## SERVICE BULLETIN

**NUMBER:** 06-46-14

**SUBJECT:** Revised Brake Light Switch Adjustment Procedure for DTCs C1531 and C0054

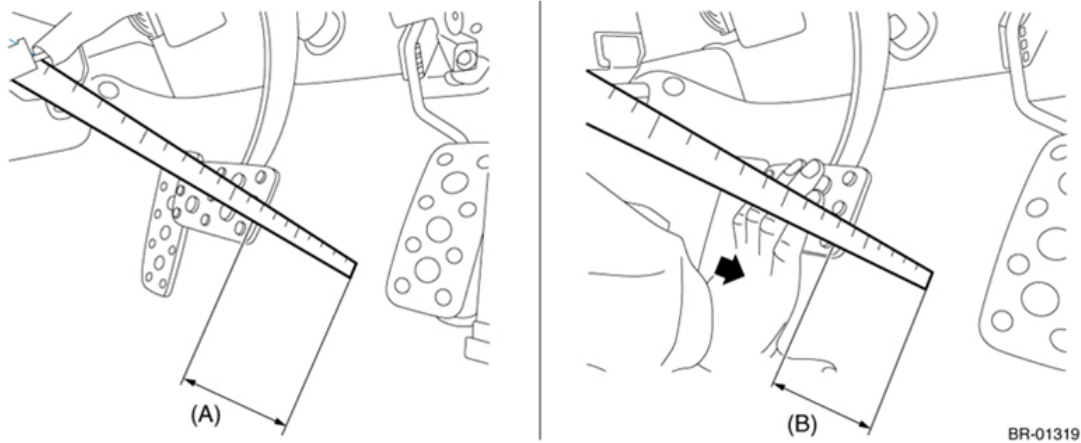
1. Before removing or adjusting the BLS, put a reference mark (a) on the threaded/notched portion as shown in the illustration below.

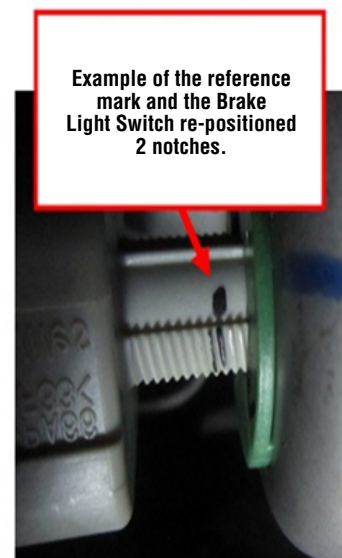
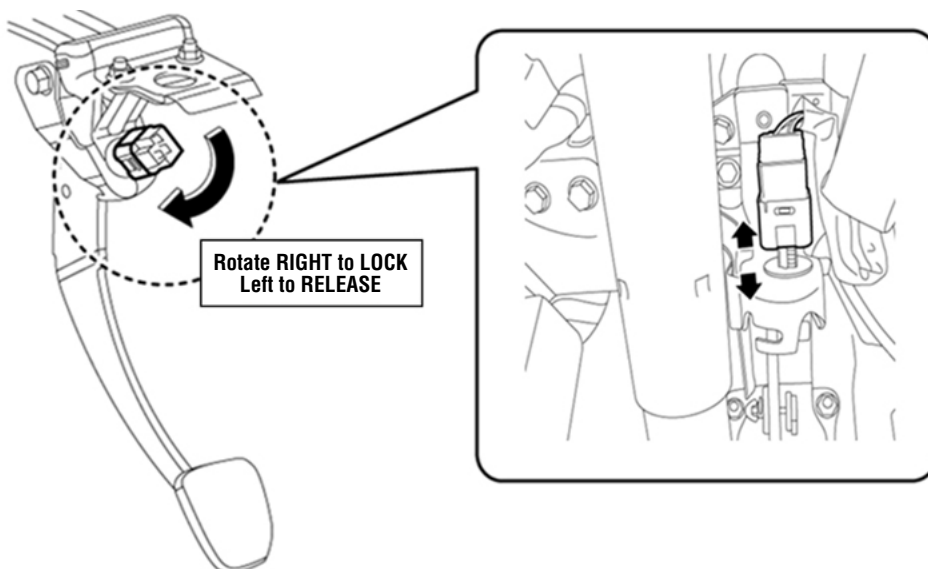
- As shown in the next illustrations, measure the brake pedal stroke by first measuring the distance “A” between the floor mat and the pedal. Depress the brake pedal slowly until the brake lights come on “B” then record the second measurement. Subtract “B” from “A” to obtain the pedal stroke measurement.

**The specification for pedal stroke to activate the BLS is 5.5mm +/- 2.5mm (>3mm but <8mm).**

- If the measurement (switch activation) is out of specification, the BLS will need to be adjusted. When the brake lights come on too soon (not enough pedal stroke), the BLS needs to be adjusted “inward” toward the bulkhead while if the pedal stroke is excessive before the brake lights come on, the BLS will need to be adjusted outward toward the steering wheel. The BLS adjustment is sensitive and in most cases, moving it just one notch should bring the operation into specification since one notch is equivalent to approximately 4mm of movement.

- If it is determined the BLS needs adjustment, rotate the switch approximately 45 degrees to the left (counter-clockwise) to release it from the pedal bracket. You will need to develop a “feel” for the adjustment notches along with how the BLS releases and locks back into place. Move the BLS inward or outward as required using your reference mark (see Step 1) as a guide then rotate the BLS to the right (clockwise) to lock it back into position. Re-measure the pedal stroke. If the switch operation is within the specified limits, the adjustment procedure is complete. If the switch operation is still out of range, repeat the adjustment procedure.
